# *City of Brisbane*

## *Planning Commission Agenda Report*

**SUBJECT:** **Parking Use Permit UP-1-20 and Grading Review EX-1-20; 130 Sierra Point Road;** R-1 Residential District; Use Permit to allow for nonconforming interior dimensions of a two-car garage and Grading Review for approximately 150 cubic yards of soil cut and export to accommodate a new single family dwelling on a 5,000 square-foot lot with a 33% slope; Wilson Yu, applicant and owner.

### **SUPPLEMENTAL REPORT**

**A202**

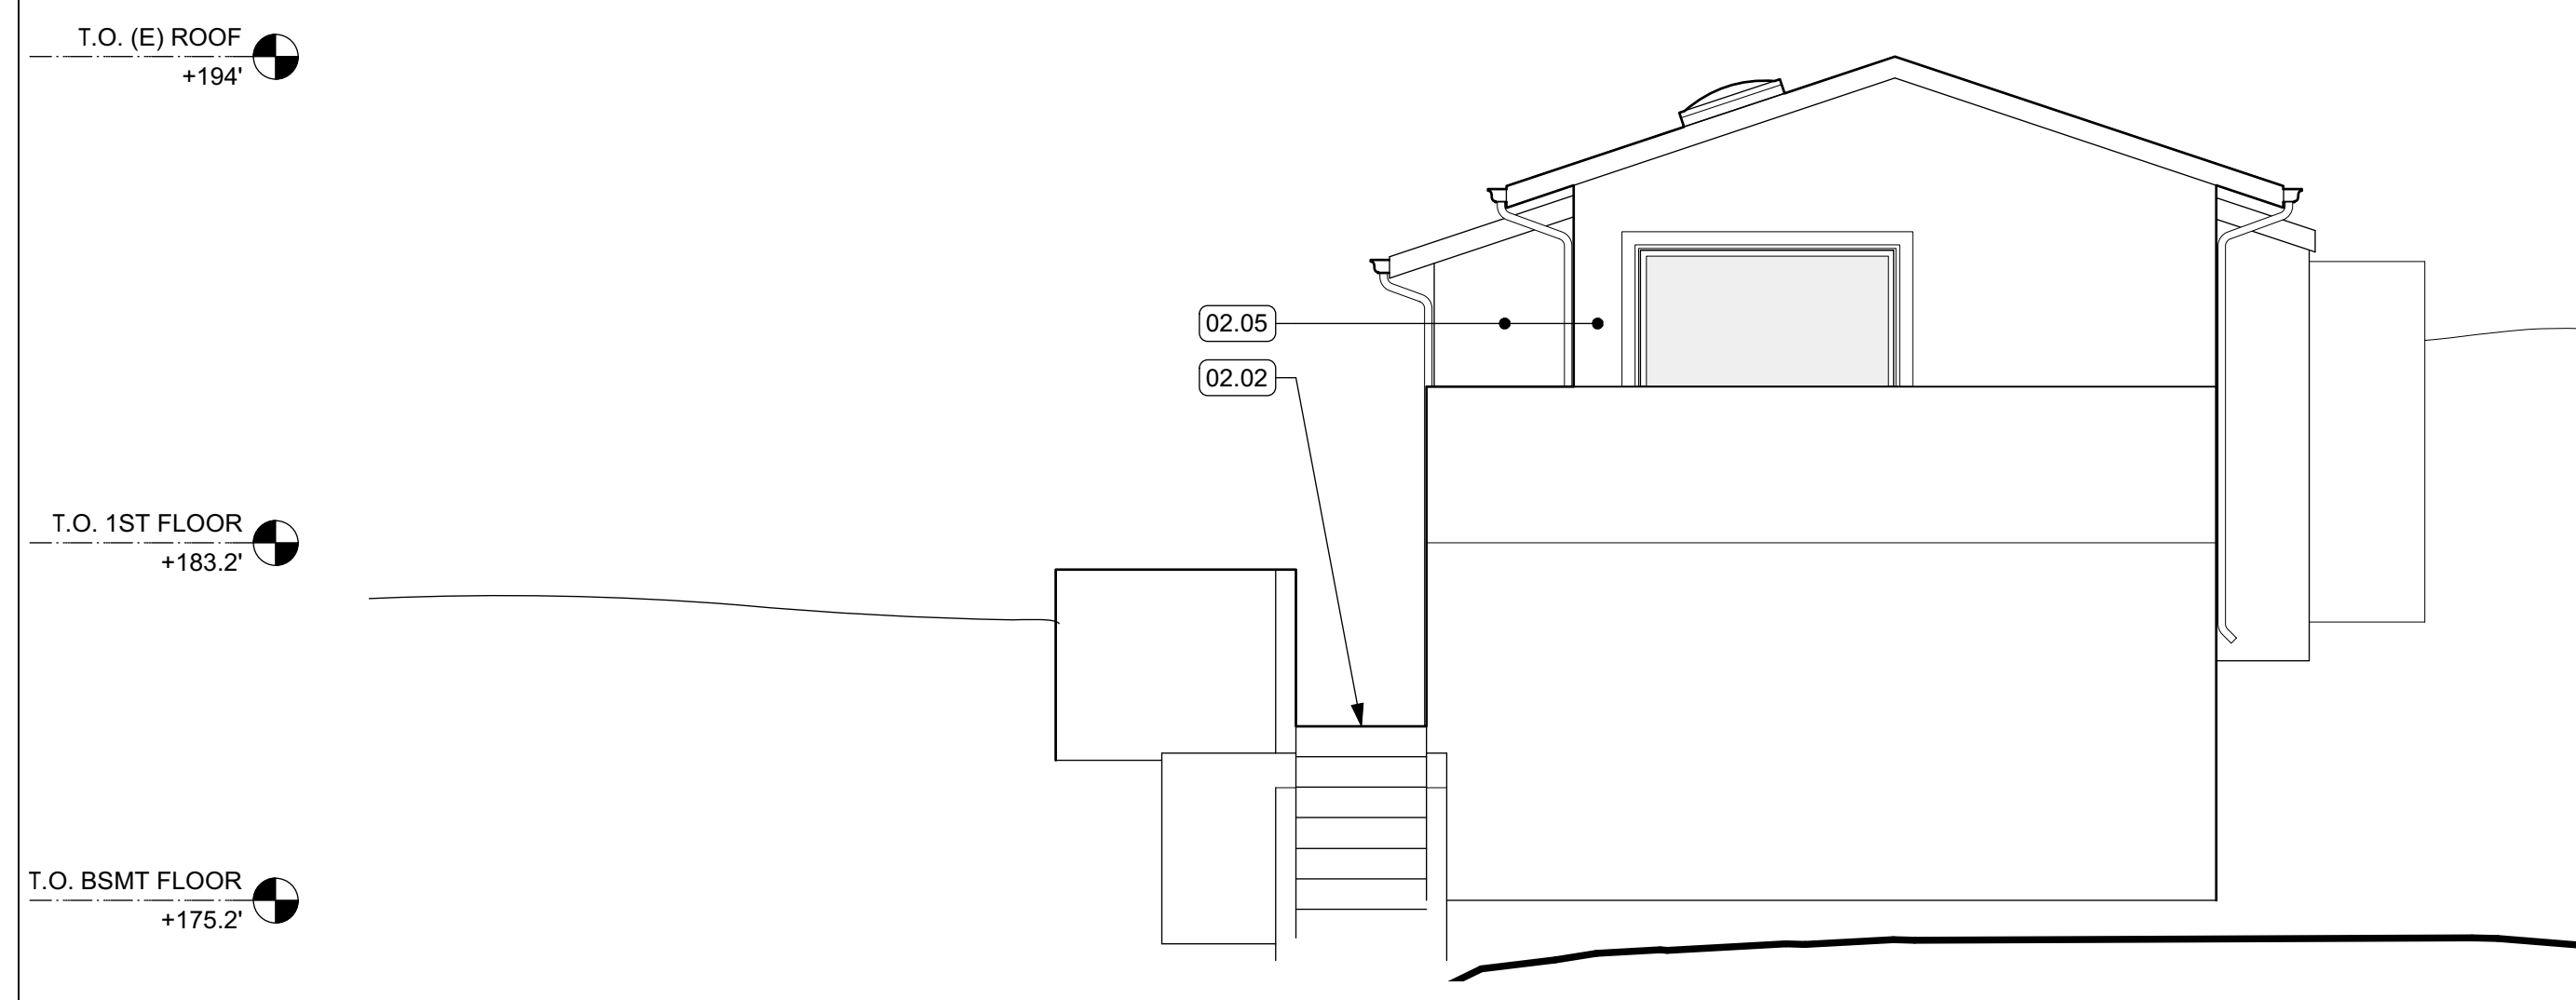
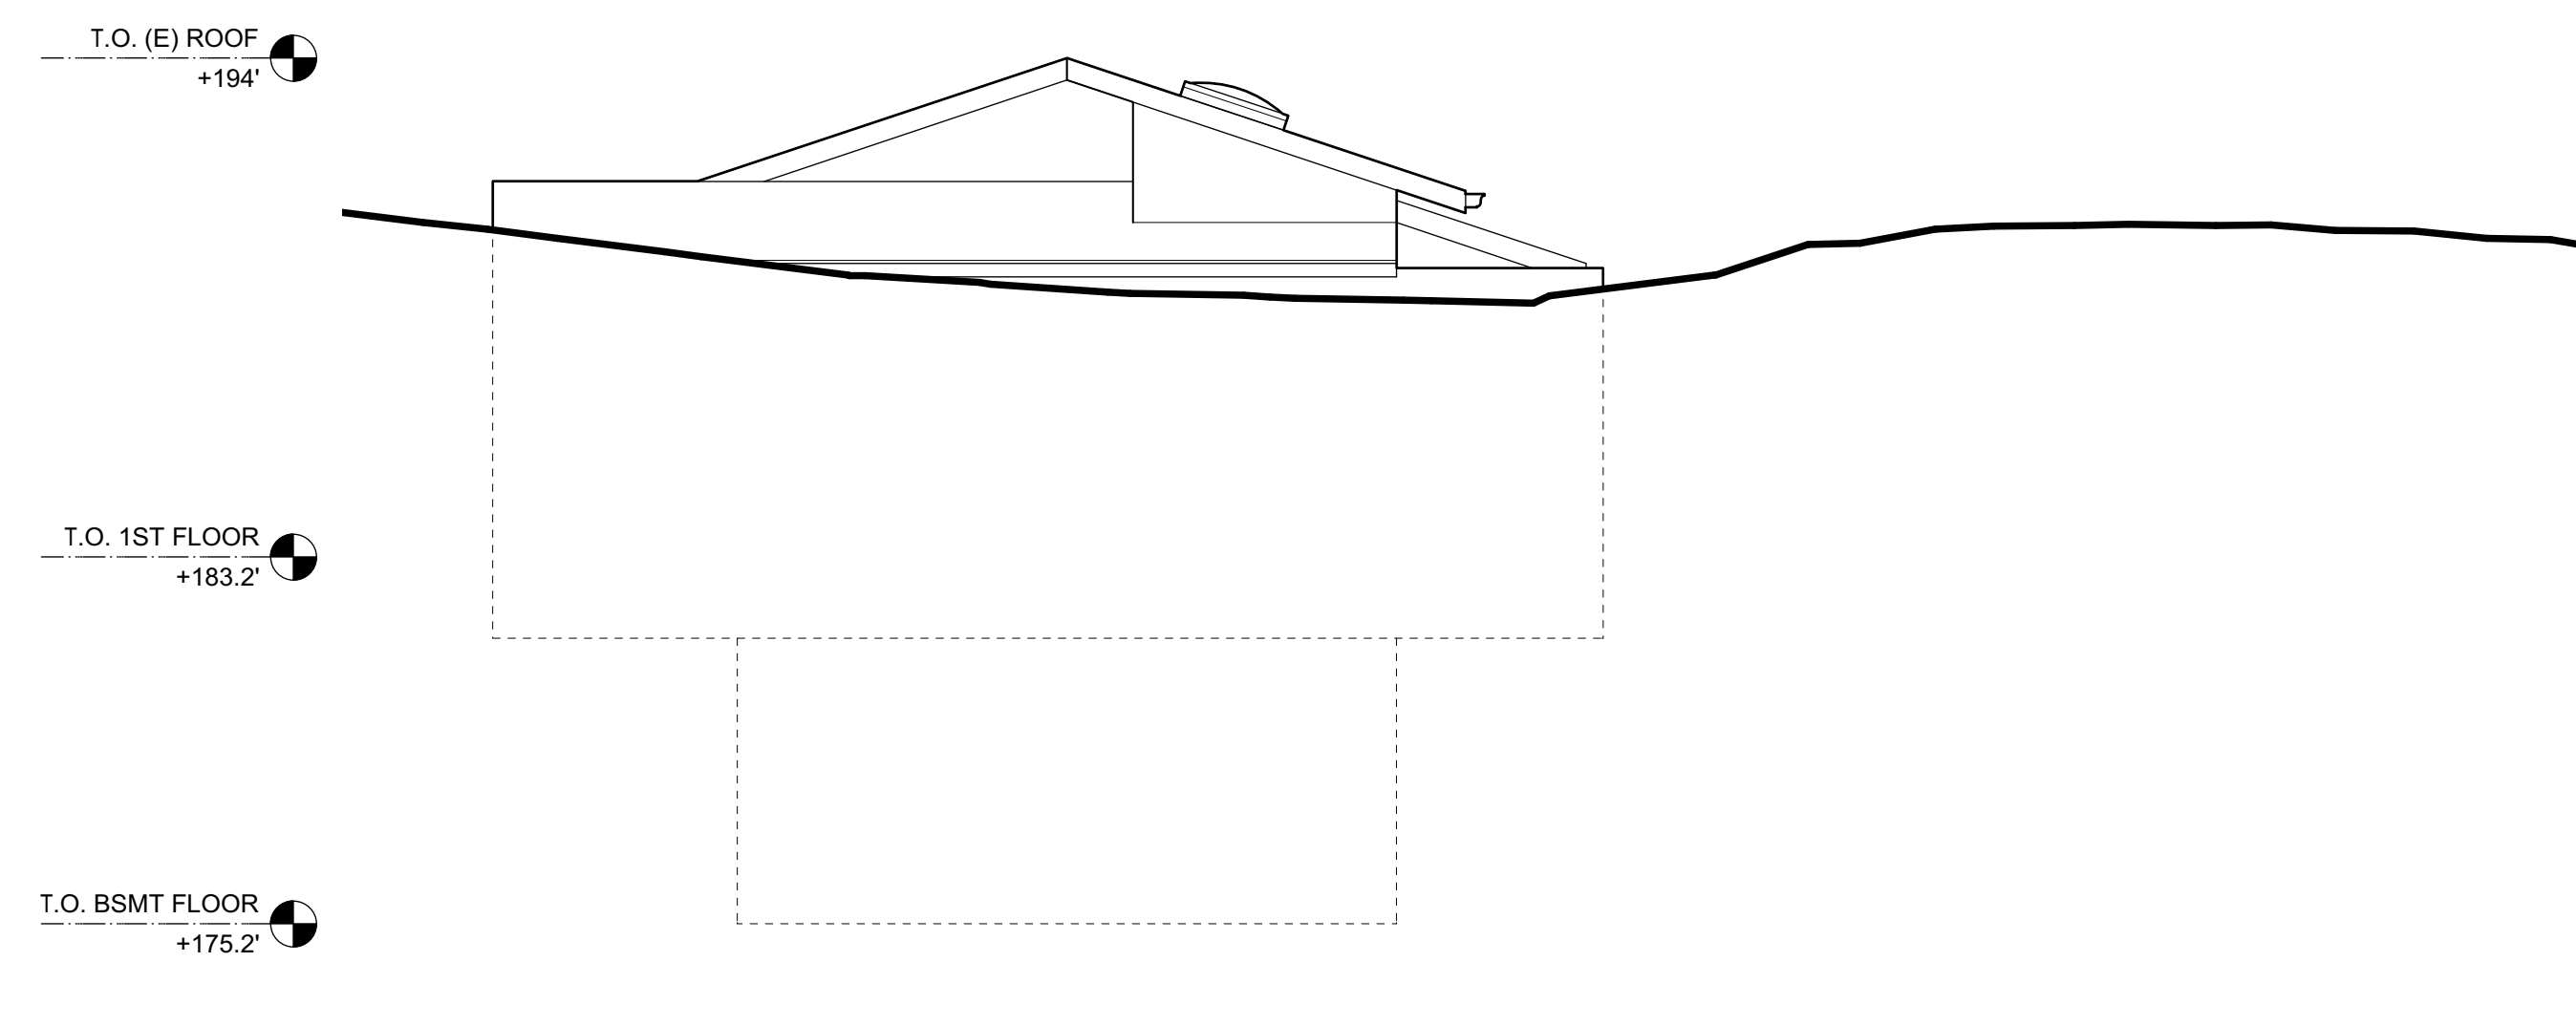
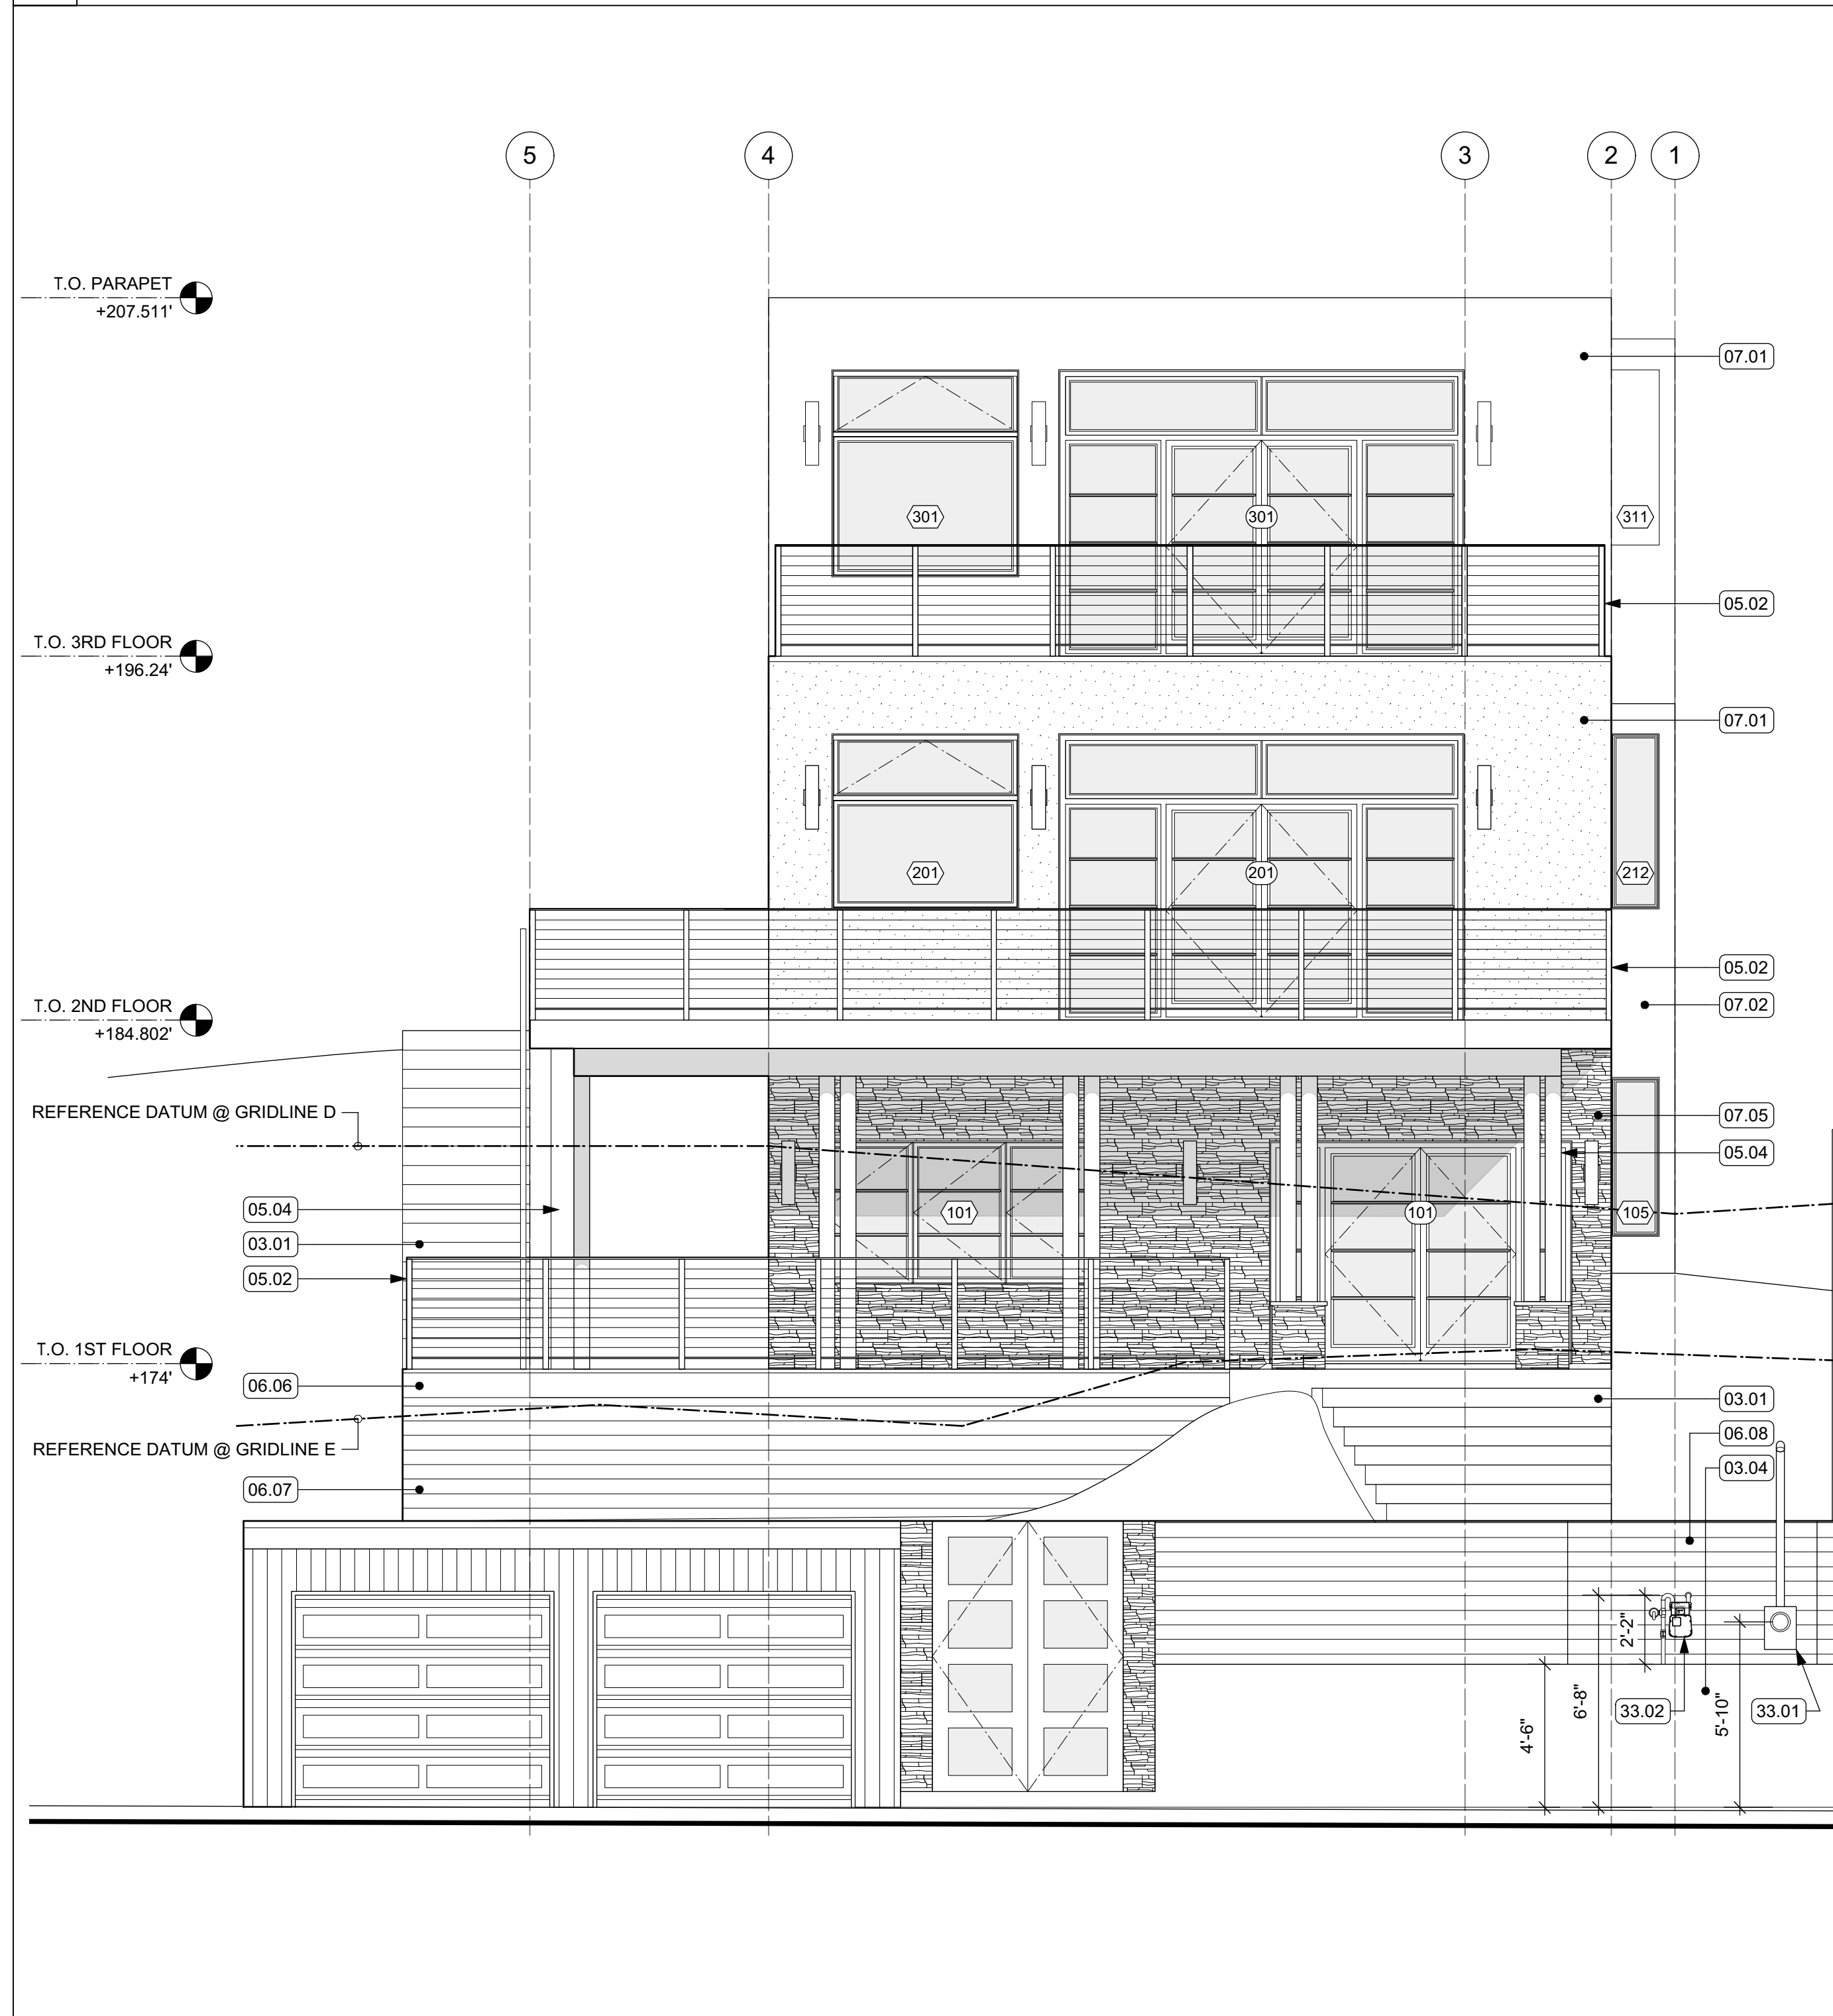
Large, exposed retaining walls are avoided or not visible from the street. BMC §17.32.050 permits retaining walls less than six feet in height within any setback area. Walls that exceed six feet in height in a setback area require vegetative screening or wall treatments to break up the massing of the wall. A proposed 4' 6" retaining wall along the front lot line will accommodate the required on-street parking (see sheet A202 of the applicant's plans, Attachment E.i).
